AMENDMENT OF SOLICITATION/MODIFICATION OF CONTRACT

2. AMENDMENT/MODIFICATION NO.	3. EFFECTIVE DATE	4. REQUISITION/PURCHASE REQ. NO.	5. PROJECT NO.(If applicable)
0005	09-Aug-2007

8. NAME AND ADDRESS OF CONTRACTOR (No., Street, County, State and Zip Code)		
	X	9A. AMENDMENT OF SOLICITATION NO. W917PM-07-R-0088
	X	9B. DATED (SEE ITEM 11) 12-Jul-2007
		10A. MOD. OF CONTRACT/ORDER NO.
		10B. DATED (SEE ITEM 13)
CODE FACILITY CODE

This amendment supplies needed information in support of ammendment 0004.

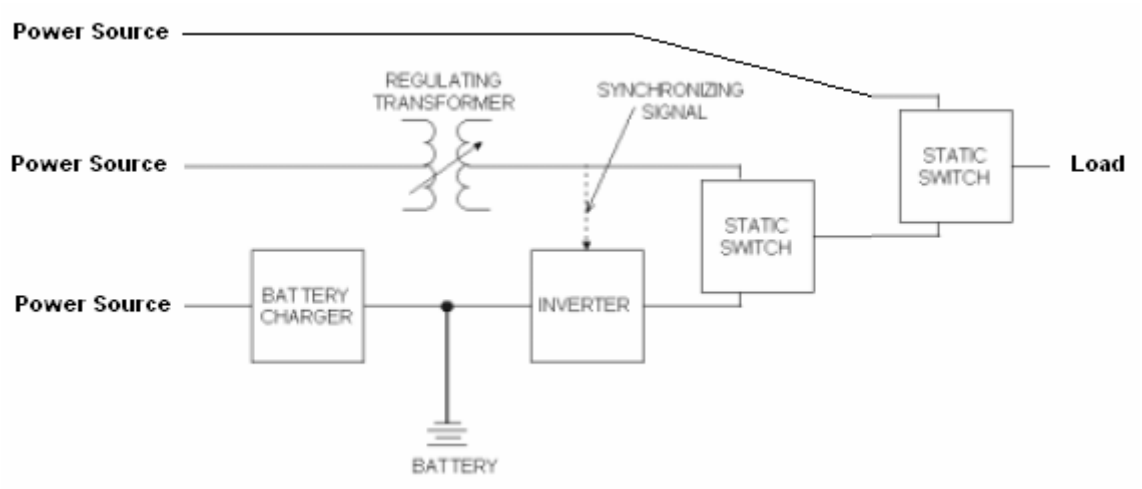
Parallel to the UPS system shall be a Regulating Transformer (aka Servo Motor Voltage Stabilizer) with a manual transfer switch. Regulating Transformer shall be of same rating as the UPS. A Manual Transfer Switch (MTS) shall be provided to bypass the UPS and instead use the Regulating Transformer.

A Manual Transfer Switch shall be provided to by-pass the UPS and Voltage Stabilizer in the event of a major problem with both units. See diagram. (Static Switch & Manual Transfer Switch are used interchangeably). Automatic Transfer Switch between base power and Communications Building Stand-by Generator are connected to the power source end of the diagram below.

SHEET C-6

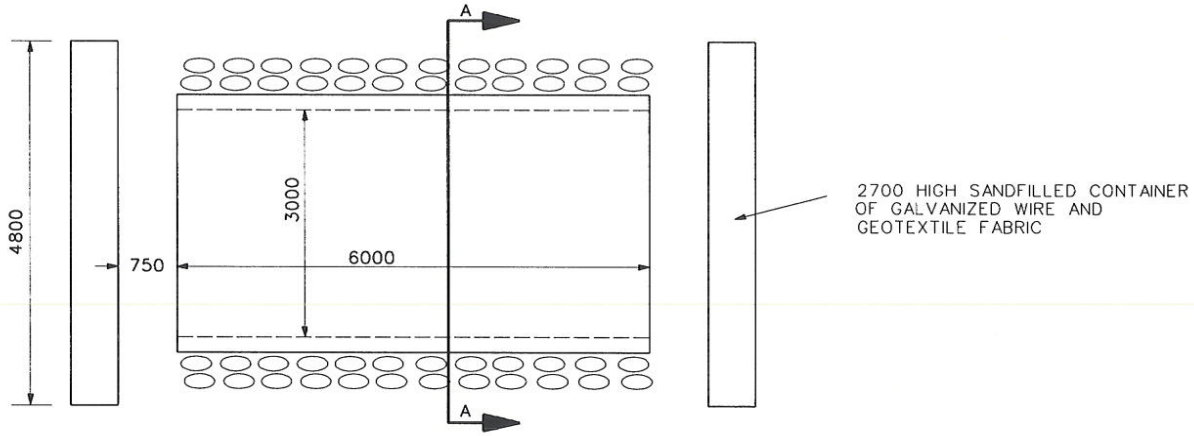
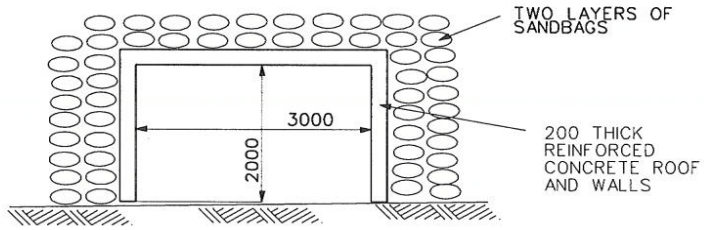
2.32 CONCRETE BUNKERS
Provide Concrete Bunkers though out compound; with seating for 1200 persons. Site and grade so water cannot stand inside bunkers. Provide 150 mm base course of gravel under sandbags. See Appendix A for layout.

4. Added Questions and Answers
5. Added Appendix A Concrete Bunker
6. Deleting Appendix C Volume 2 of 3, Refueling Point Drawings
